CITY OF PORTLAND, MAINE
Department of Building Inspection

LOCATION **Conco Road**

Check of plans filed with application for permit for construction of a one and two story masonry warehouse and office building at the above named location discloses questions as to compliance with Building Code requirements as listed below. Before a permit can be issued it is necessary that information be furnished indicating compliance with requirements. Details in question are as follows:

Your application to change the use of 212 Canco Road from warehouse to inserting operation of news papers, has been reviewed and a permit is herewith issued subject to the following requirements:

Sheet 1:
FLOOR PLAN

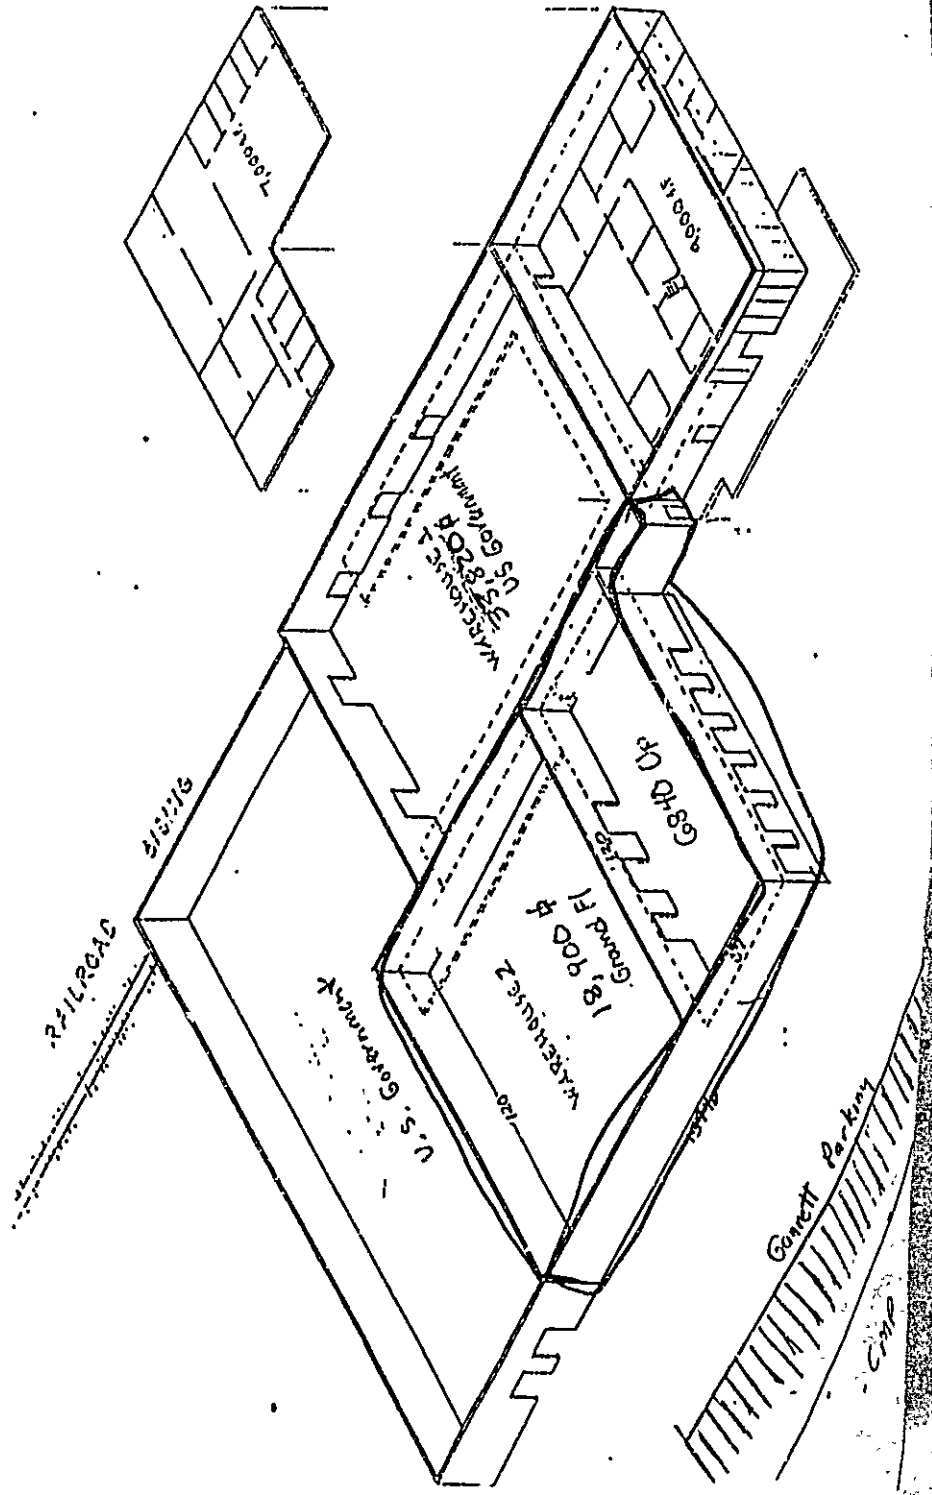
Your permit to change the use from warehouse storage for appliances to inserting for production operation, as per plan, is being denied.

Lt. Collins for review under NFPA has denied the permit for inadequate exiting as indicated on plans. Please contact Lt. Collins for further discussion on exiting.

1. Provide second approved means of egress;
2. All aisles are to be stripped with a contrasting color;
3. Provide a flow switch to the main riser which will trip horn and light sounding devices throughout; and,
4. Provide emergency lighting and illuminated exit signs as required.

121 Floor Reflected Ceiling Plan

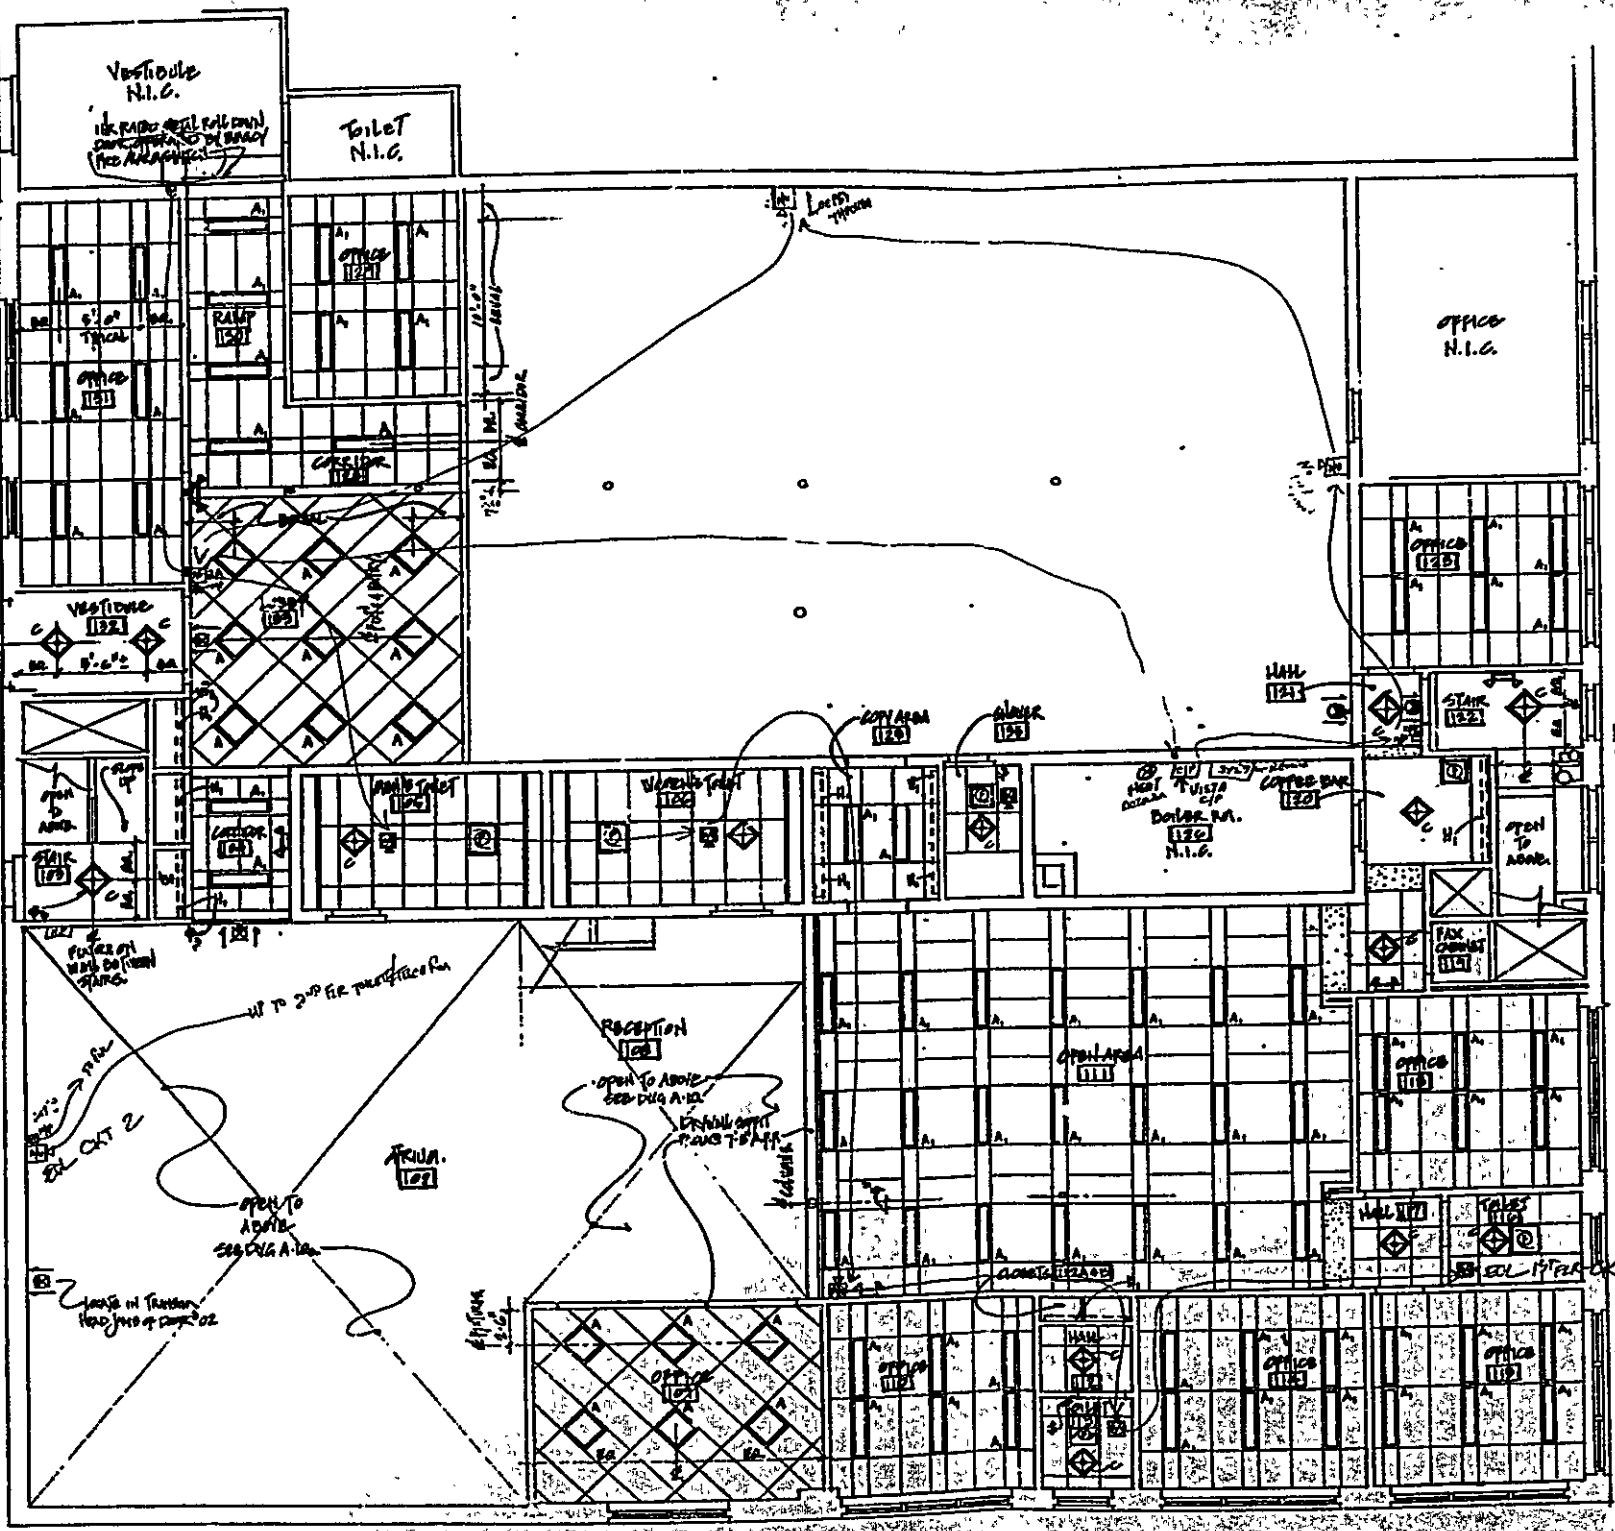
FIXTURE QUANTITIES, TYPES & LAYOUT
 REVISED; SEE DWG A-102A & B

CHANGE TYPE B FIXTURE TO
 REVIS'D TYPE A FIXTURE @
 CORN FR 201

37 B FIXTURES REQUIRED IN 44A; FINISH @ AREA 202/203
 SEE DWG A-102A REVIS'D RFL CLG PLAN.

CHANGE TYPE B FIXTURES
 IN OFFICE # 203 & 205
 TO REVIS'D TYPE A FIXTURES
